37 Arlington Road NW1 7ES refs. 2021/3631/P

Delegated Report (Members Briefing)		Analysis sheet		Expiry Date:		22/09/2021	
		N/A		Consultation Expiry Date:		15/11/2021	
Officer				Application Number(s)			
Josh Lawlor				2021/3631/P			
Application Address				Drawing Numbers			
37 Arlington Road London NW1 7ES				See draft decision notices			
PO 3/4		Area Team Signature		C&UD		Authorised Officer Signature	
Proposal(s)							
1. Installation of a glazed canopy to rear ground floor.							
Recommendation(s):		1. Grant Conditional Planning Permission					
Application Type:		1. Householder Planning Permission

Proposal: Installation of a glazed canopy to rear ground floor.

Image 3 (above): Rear elevation

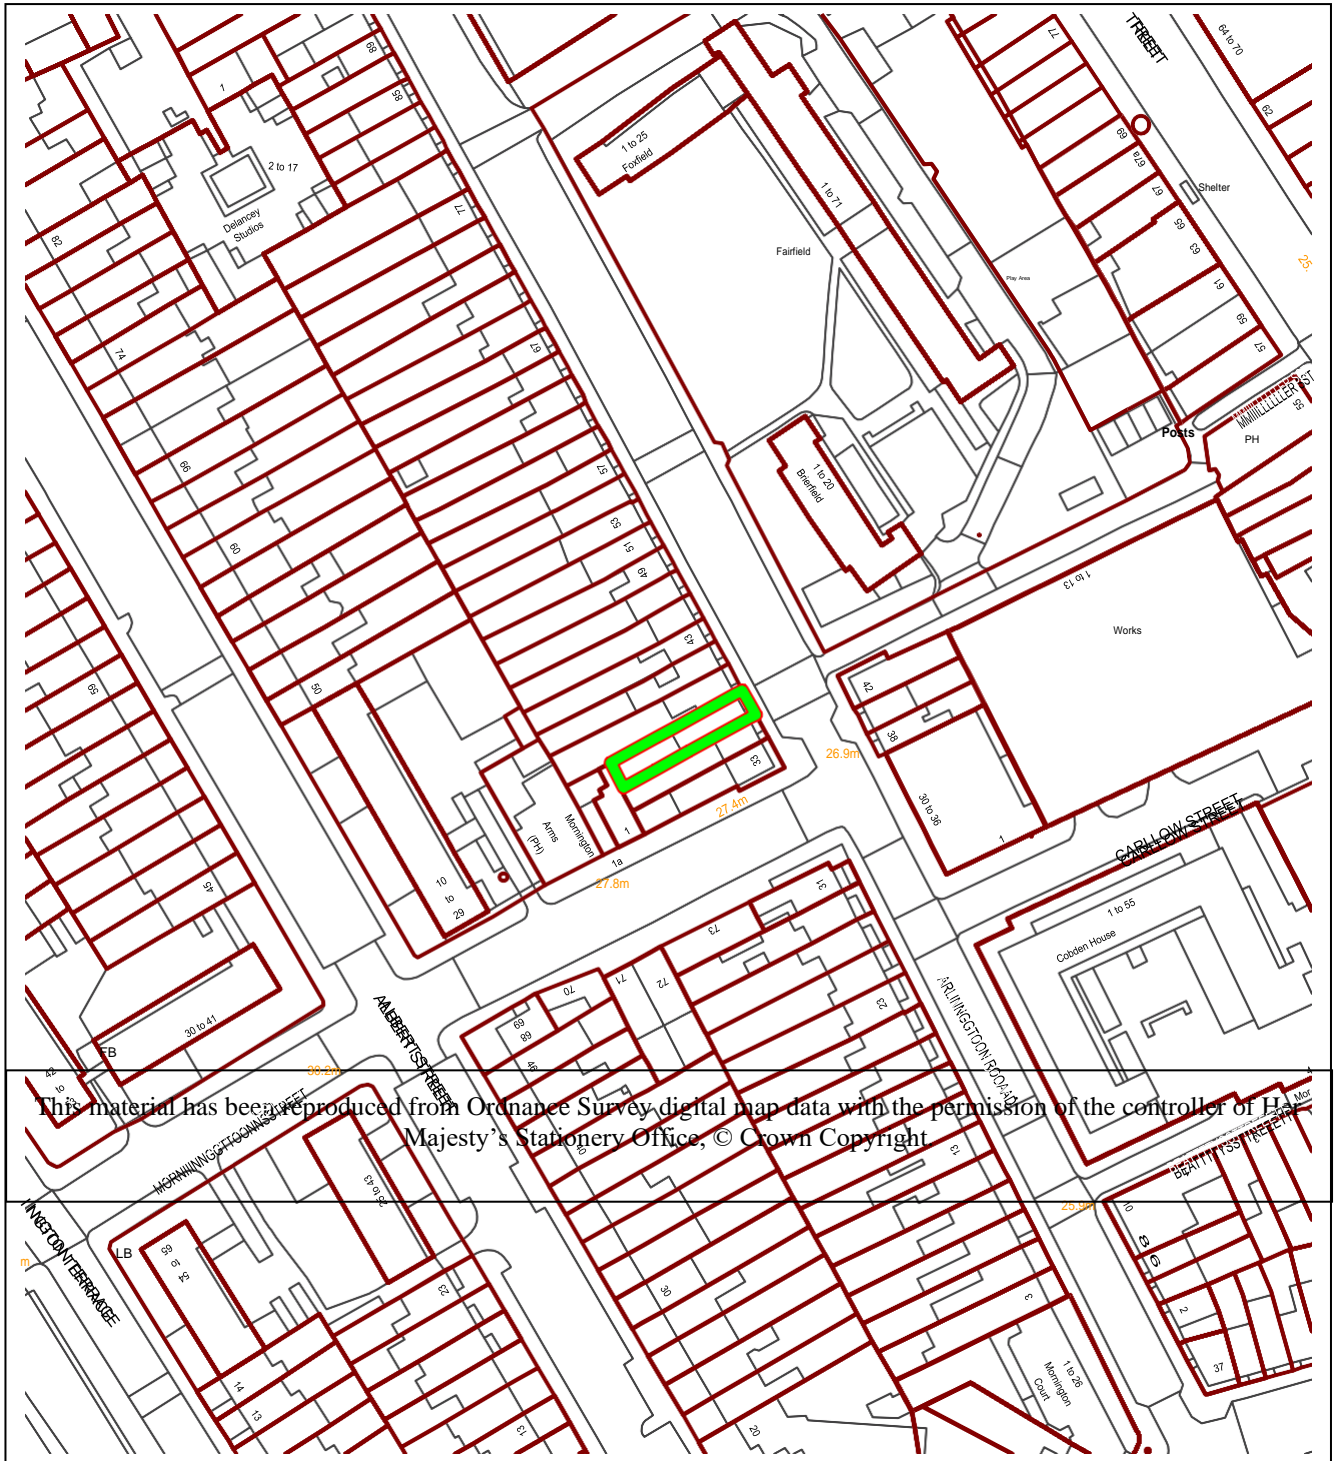
The specific interest of the rear facade includes the roof form with rear slated mansard which has a sweeping tilt to its lower courses, and the strong vertical emphasis provided by the large rear chimney stack on what is a diminutive building.

As is seen in the attached photograph the uniform height of the chimney stacks is a highly significant element and is visible in views from the public realm. The proposal to raise the stacks above this height (for both no. 37 and, strangely to its neighbour at no. 35 also) has a detrimental impact to the host dwelling and its neighbours, including the setting of the Listed terrace immediately to the north of no. 37.

The addition of a mansard roof to the dwelling also detracts significantly as it infills the skyline behind the chimney stacks, thus interrupting the visual integrity of the last seven houses where the stacks rise above the second-floor mansards in a regular rhythm. The negative impact of an additional storey on this form may be seen further along the terrace in the photograph.

The Committee considers that the proposed "mansard on a mansard" at the rear is highly detrimental to the host dwelling, overwhelming the host building's scale in view of its bulk (with a taller height than the floors below and fully exposed raised party walls), and as a consequence it neither preserves nor enhances the Conservation Area. The mansard at the front will also look incongruous in view of the fact that there are no mansards to the south of no. 47 and because no. 37 is prominent in longer views from Miller Street.

<p>proposed raised southern party wall will look incongruous and unsympathetic to the host dwelling, as can be seen in the attached photograph which includes a mansard at 47 (approved prior to CA designation) for context.</p> <p>The specific interest of the rear facade includes the top storey slated mansard which has a pleasing sweeping tilt to its lower courses, and the strong vertical emphasis provided by the adjacent large chimney stack. The uniform height of the stacks in the terrace is a highly significant element - their prominence resting on the fact that they visually break the roof line and appear tall in relation to the brick facade below the mansard. Raising the party wall between 37 and 39 considerably diminishes this effect, and increasing the height of 37's rear chimney does not mitigate this impact owing to the fact that two chimney stacks (being 37 and 35 as proposed) will then be taller than all the others in this contextual view. The prominence of the Listed chimney at 39 will be lost as a consequence and the uniformity of the terrace will be significantly harmed.</p> <p>The raised party wall will also look incongruous and over-tall to the front and this elevation is prominent in longer views from Miller Street and Arlington Road, where the diminutive scale of the terrace is especially apparent.</p> <p>The Committee notes that a mansard roof extension at 5 Mornington Place (part of a short terrace of similar scale to 33 - 45), was recently refused due to its prominence - including the raising of the party walls which are very visible. An appeal was dismissed and the houses have been subsequently listed.</p> <p>For the above reasons it is considered that the proposed raising of the party wall at no 39 is detrimental to the listed host dwelling, overwhelming the house's scale in view of its bulk (with a taller height than the floors below) and neither preserving nor enhancing the listed asset or the wider</p> <p><i><u>Officer response:</u> The mansard roof extension has been removed from the proposal</i></p>

Image 5 (above): Long section showing canopy with removable glass roof

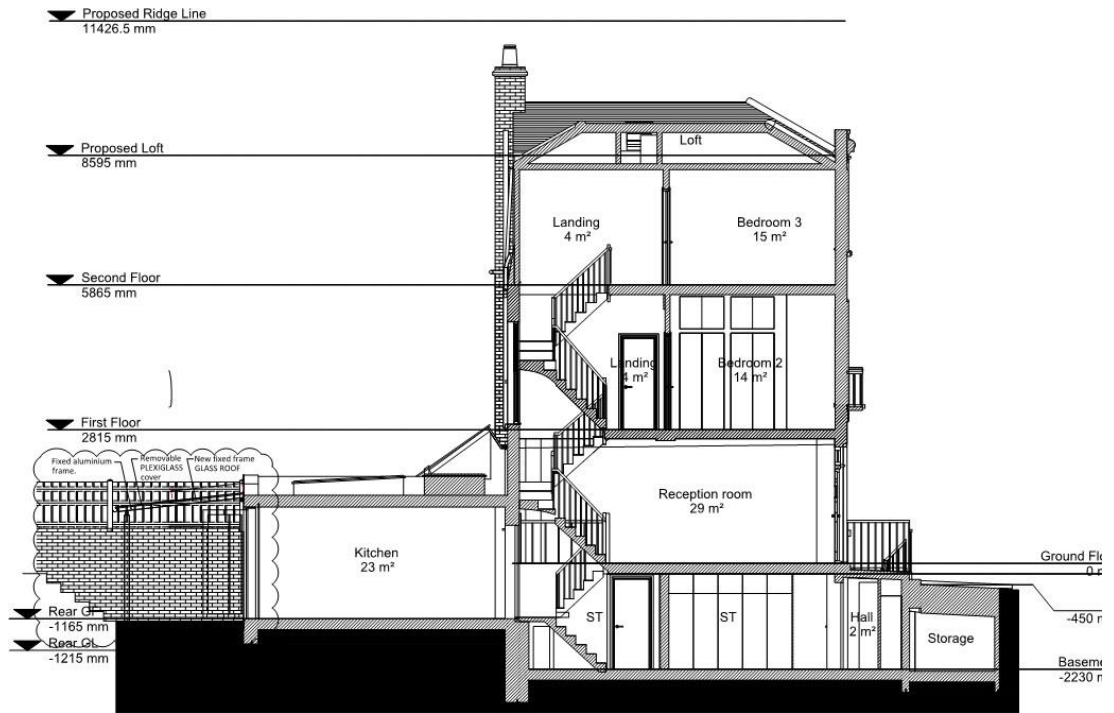
1.1. Planning permission is sought for a glazed canopy at the rear ground floor. It would attach to the existing rear extension and not be fixed to the adjacent listed wall.

- 4.4. The glazed canopy would be a lightweight installation that would not be visually prominent from within the public realm. It would be set below the neighbouring boundary wall/trellis and not be attached to the garden party wall. The canopy would be supported with two slender steel columns and is a reversible installation. The glass can be removed when not in use. It would be fixed on the rear facade above the kitchen door, like the cover of the attached neighbour at no.35. As it is a canopy it would not increase floorspace or take up garden space. A large garden would be retained following the development.

- 4.5. The applicant has followed the recommendation of a party wall surveyor and proposed to mount the pillars onto the existing concrete away from the garden party walls. This would ensure the canopy would be freestanding and not fixed to any listed features. Therefore, it is not considered that it would harm the character and appearance of the conservation area or impact the adjoining listed boundary wall or its setting.

5.2. The glazed canopy is set below the neighbouring boundary wall and as such would not unacceptably impact on light or outlook to windows at neighbouring properties.

- The removal of the mansard roof extension and raising of party wall
- The glass canopy now has a removable glass roof, so it is more of a temporary installation
